Maserati Technical Bulletin

Date: July 6th, 2016
Bulletin No. MAS000881 EPB Bowden Cable
Insulation
Service Campaign 305
Supersedes: NA

SUBJECT: Service Campaign 305 – EPB Bowden Cable Insulation

Fig.2

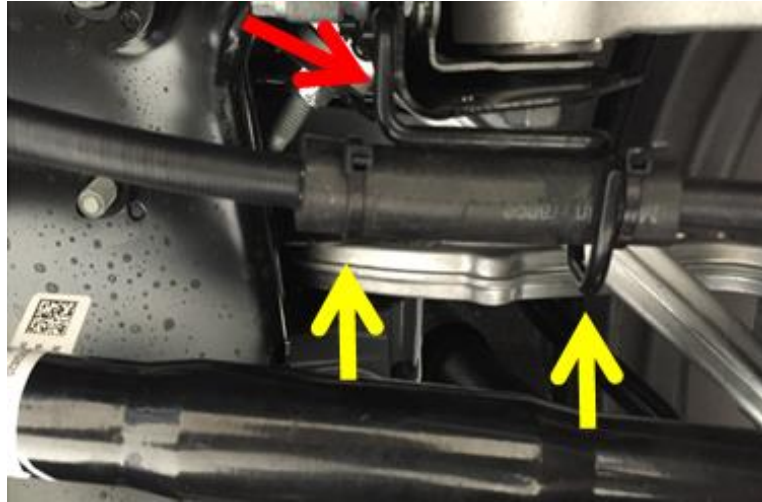
2. Drive the vehicle onto a lift and check if the rubber insulation sleeve is installed on both sides of the vehicle. (Fig.2)

- If the sleeves are present, install the cable (wire) ties to the sleeve as shown in Fig.2.
- If one or both rubber sleeves are missing, install them using 2 cable (wire) ties on each sleeve as shown in Fig.2.

NOTE: When installing the sleeves, make sure they extend through the guide bracket (red arrow, Fig.2) before securing them with the cable ties.

- Trim the excess material off of the ends of the cable ties when secure.
